# **A G E N D A**

## **Architectural Review Board**

**February 28, 2017**

2023 Madison Ave

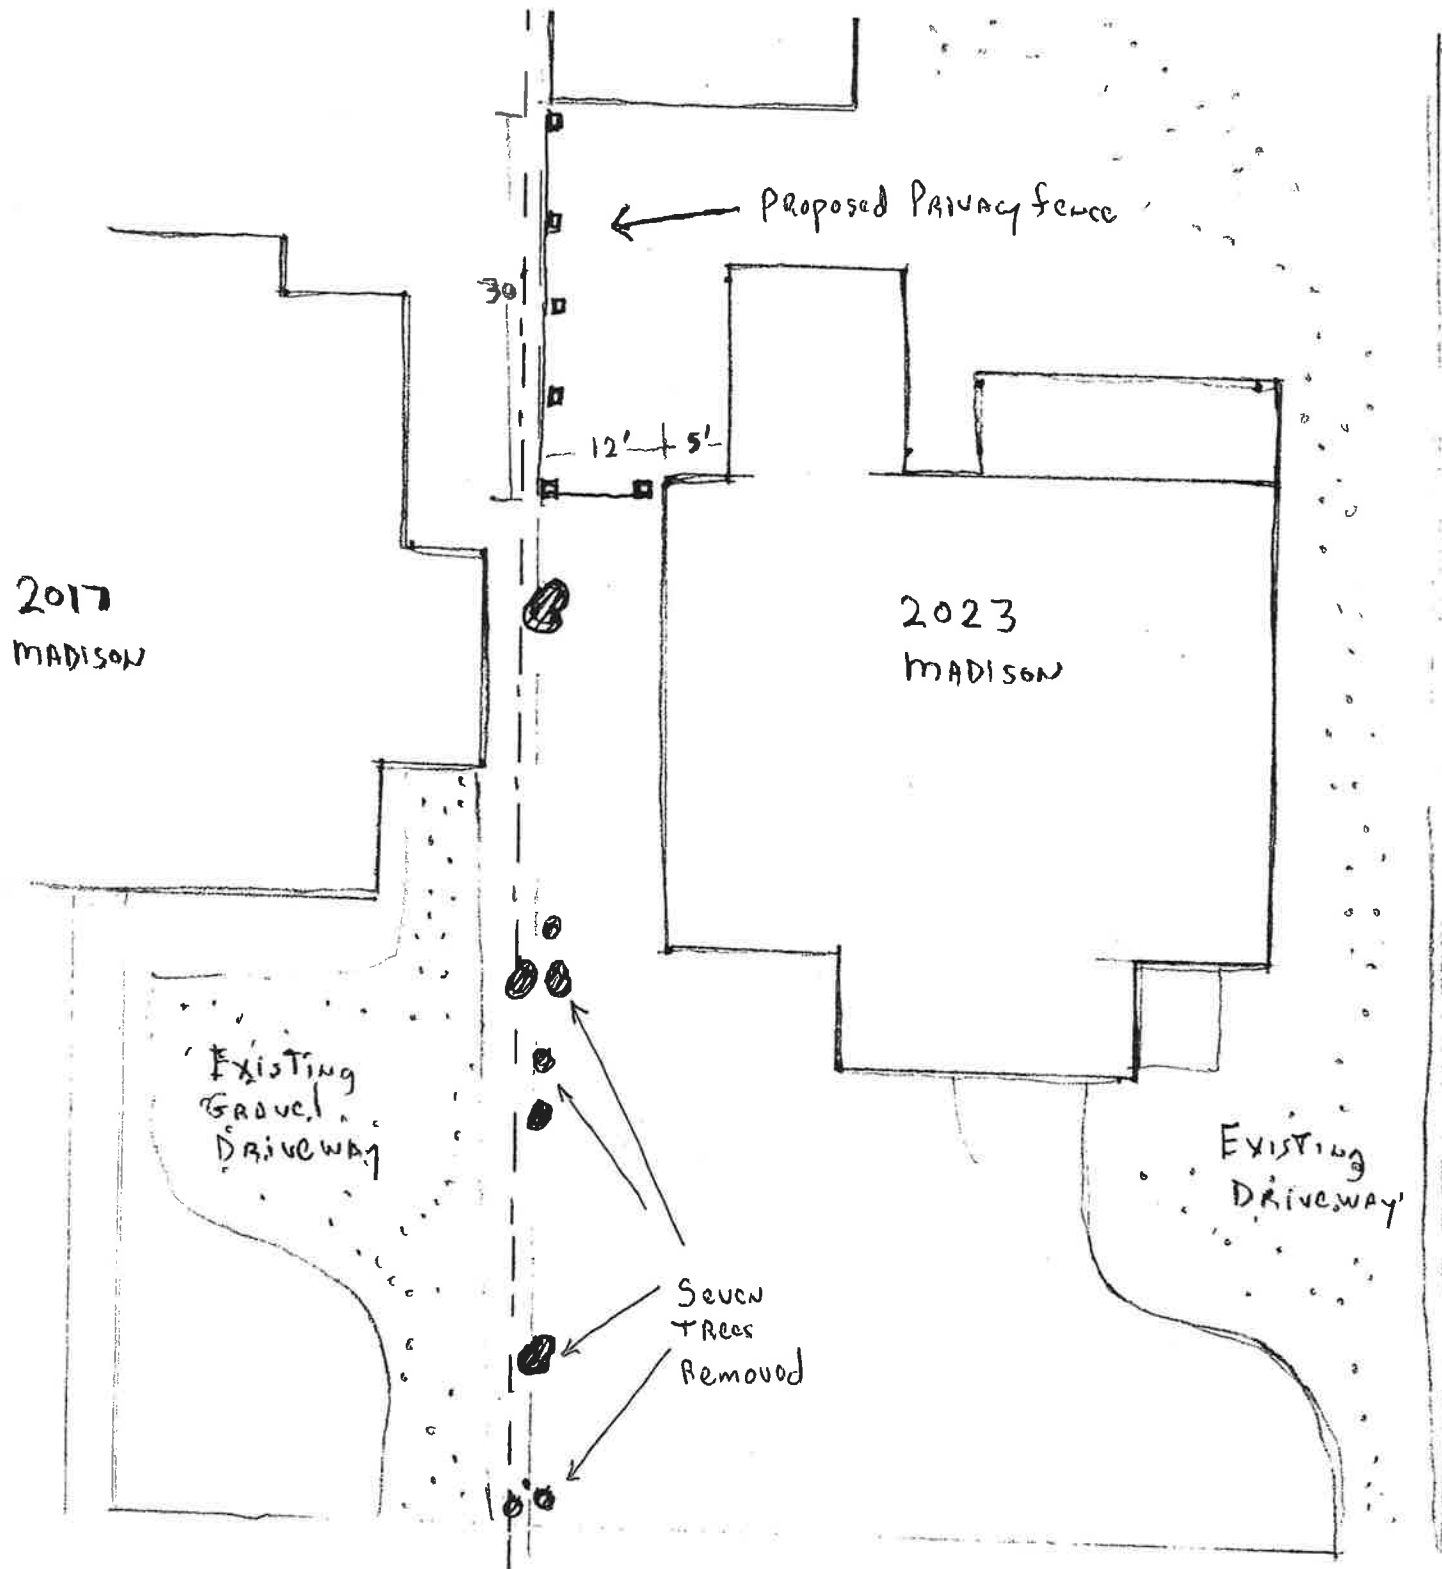
**REMARKS:** The petitioner is seeking permission after the fact for 8 tree removals (photos of stumps included). According to the owner, they are of various types and sizes, however, staff was not given permission to go onto the property to obtain closer pictures of the stumps.

- From pictures, stumps appear to be healthy and free of decay.
- Board will be apprised of options based on discussions with the Legal Department and Municipal Court

2537 Agnew Avenue

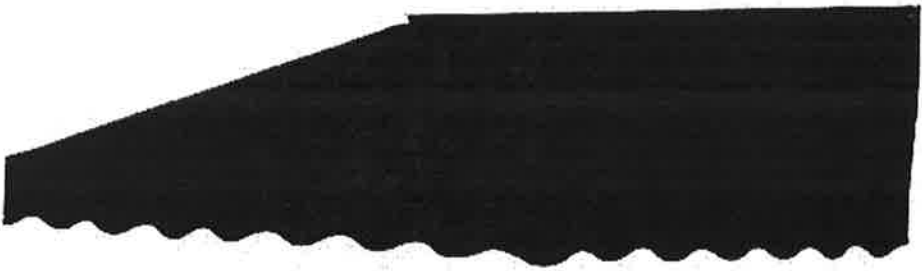
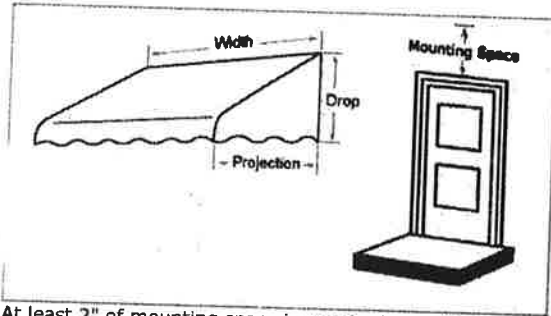
**REMARKS:** The petitioner is requesting permission to install a 36” wide awning above the back door. The style of awning is attached, the color will closely match the house trim.

The petitioner is also requesting permission to install a shutter over an existing window that is similar to one found on the other side of the house.

- No comment.

3224 Le Bron Road

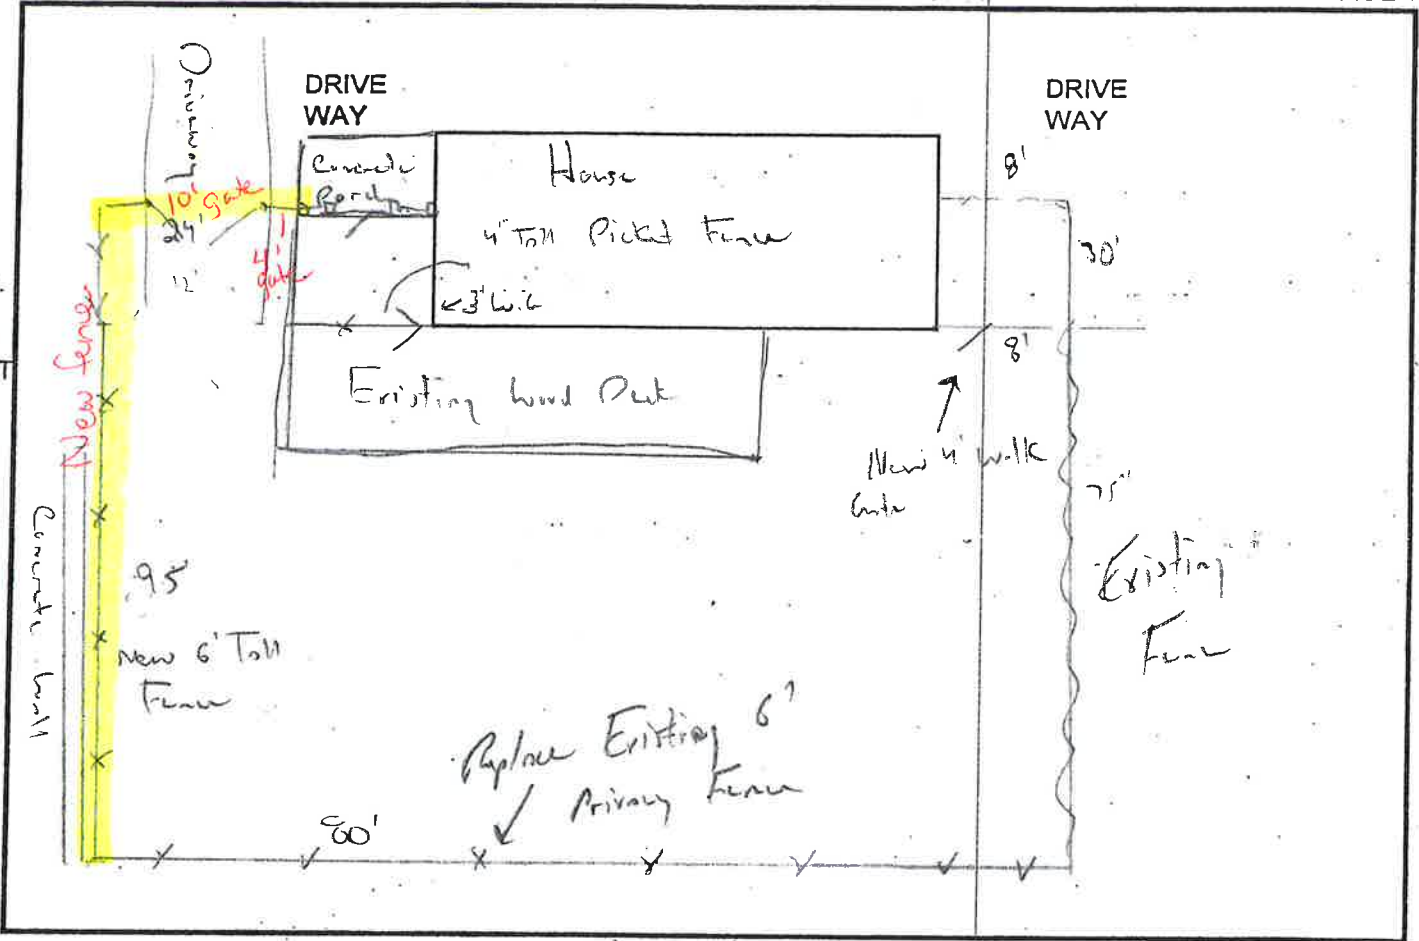
**REMARKS:** The petitioner is requesting permission to install a 6' dog eared fence to run along the north property line that will match the existing fence on the other rear yard property lines. A 10' double gate across the driveway is also proposed, which will return to the house between the front porch and the double doors. A 4' iron walk through gate in Victoria Quad style is proposed in that same stretch of fence where illustrated on the site plan. An example of the Victoria Quad is also attached.

- The Board has generally approved privacy fences, which are not a historic feature of rear yards at 6', so long as the return to the house is set back behind the front corner of the house to avoid creating a stockade effect.

3398 Le Bron Road

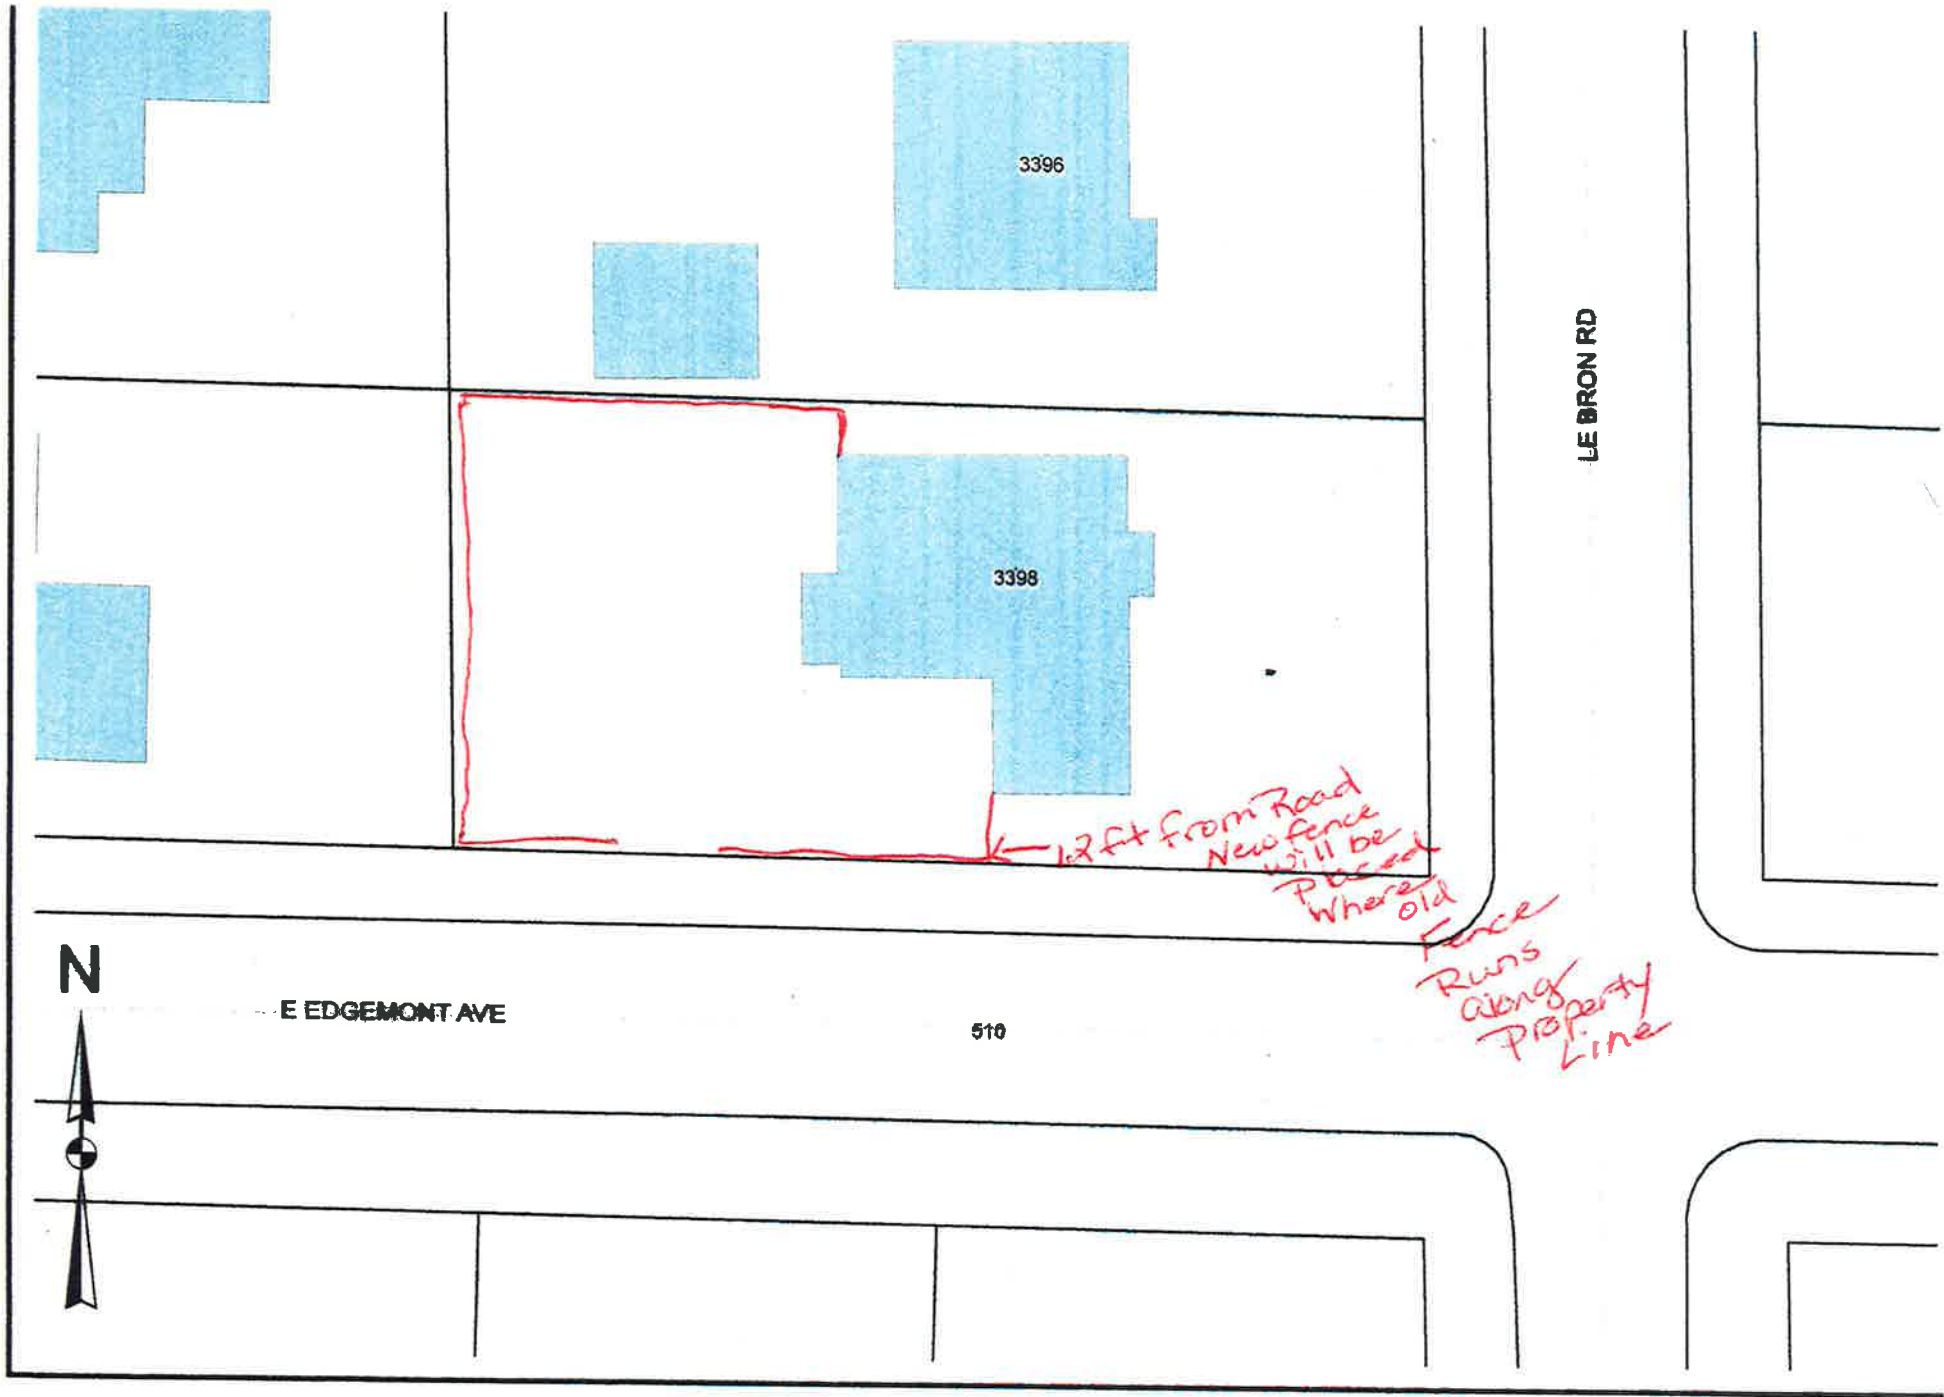
**REMARKS:** The petitioner is requesting permission to install a 6' dog eared privacy fence in the same location as the existing panel and lattice fence. The petitioner received approval for this project in 2011 but that approval has expired. The petitioner requested the required variance in 2011, which does not expire, so only approval by ARB is required.

- The Board has generally approved privacy fences, which are not a historic feature of rear yards at 6', so long as the return to the house is set back behind the front corner of the house to avoid creating a stockade effect.
- As noted above, the project was previously approved by the ARB, but that approval has expired. The scope of the project has not changed.

130 Commerce Street

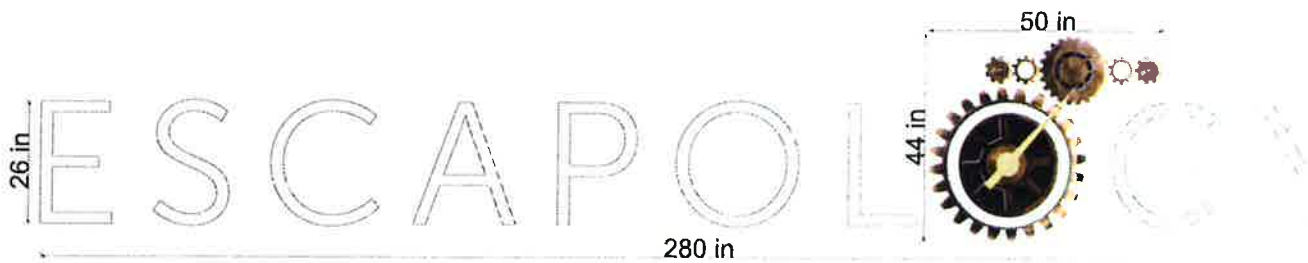
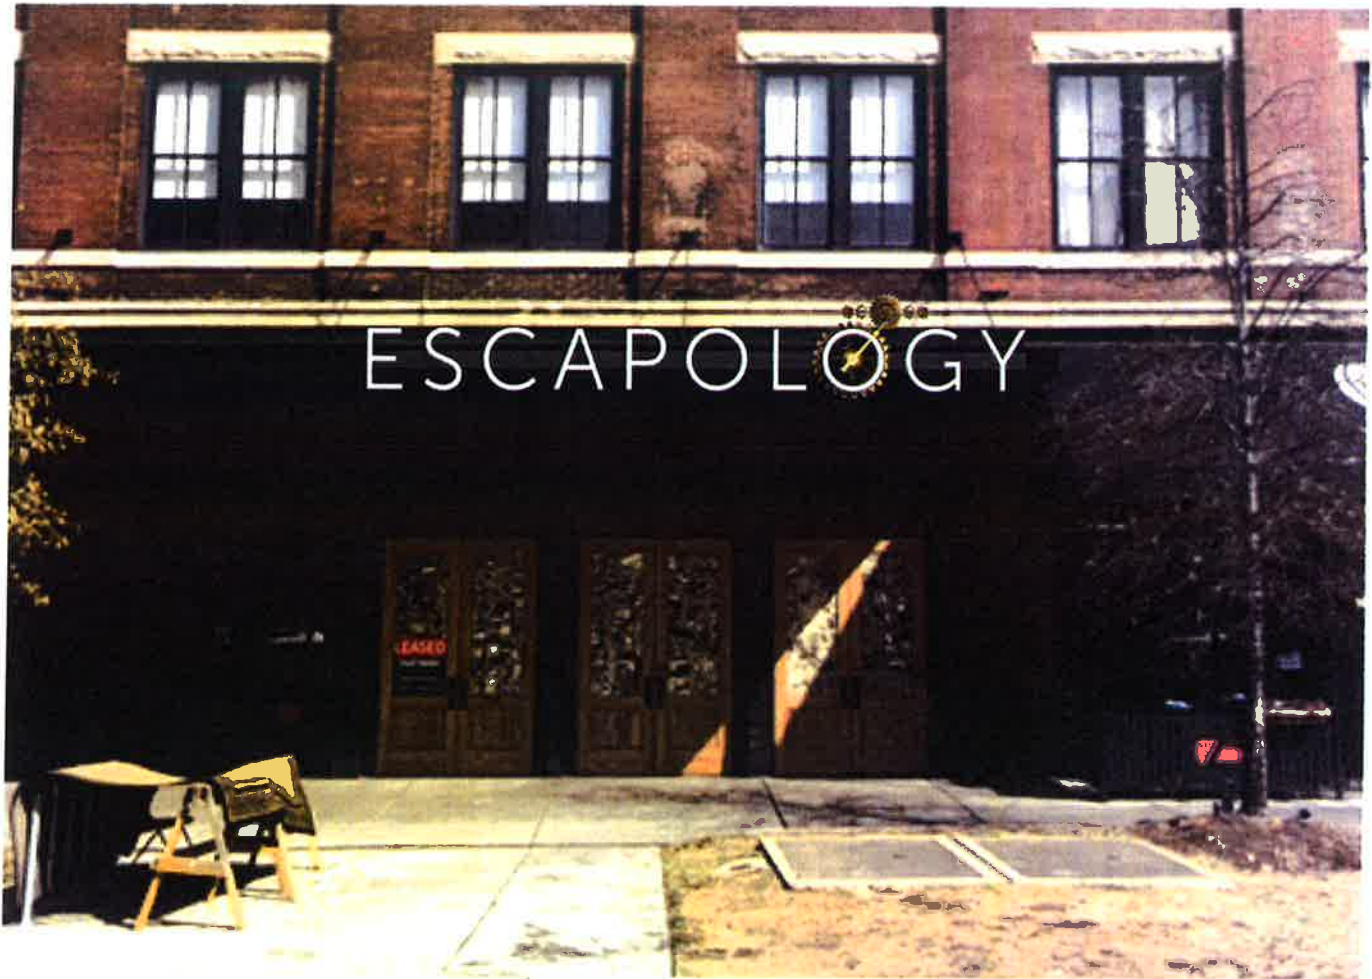
**REMARKS:** The petitioner is requesting permission to install a 26” high LED illuminated individual channel letters, mounted on a raceway that will mimic the edge of the existing canopy, with a back lit logo as illustrated.

- The design guidelines state “Proposed signs should not exceed 20 square feet of surface areas. Designs for the mounting, framing, etc. must be approved. The material for the mounting should be compatible with the materials of the building. Style and color of lettering must be compatible with the building location. Location of sign on lot must be approved. Lighting: top or ground lighting, such as floods or spots. Interior lighting, if shielded. No moved or flashing lights.”

- The wall sign exceeds the recommended 20 square feet at approximately 46 Square feet (it falls under the Smart Code band sign guidelines of 3’ tall at any length, and is 10 inches shorter than Mellow Mushroom). The Board needs to determine if the scale of the sign as proposed can be accommodated by the scale of the building.

- Technically, the letters are internally illuminated. The Board has approved signs with incised letters in opaque casings, this produces a similar effect without the casing. The logo is backlit, which was approved for Jimmy John’s 3 storefronts down.
